Subject: Tecumseh Riverside Trail

## **Subject- Riverside Trail Extension**

## Special Consideration – Various

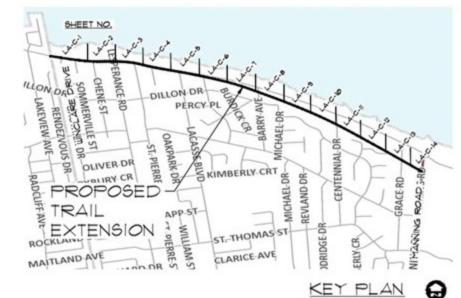
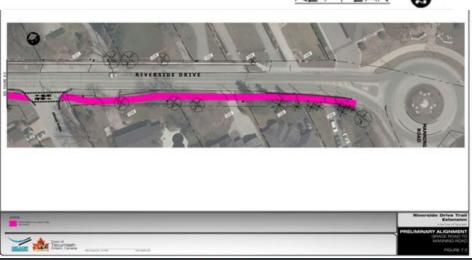
I would also ask to physically see where the trail will lie. I have reviewed all of the drawings and there is simply not space. How do you plan to address this? The actual trail needs to be marked before people on either side of the issue can factually understand what council is planning, how it will function and what the consequences are.

I request that a traffic study be conducted at the roundabout as well as a physical mapping of the actual placement of the trail on the actual land it is proposed to cross.
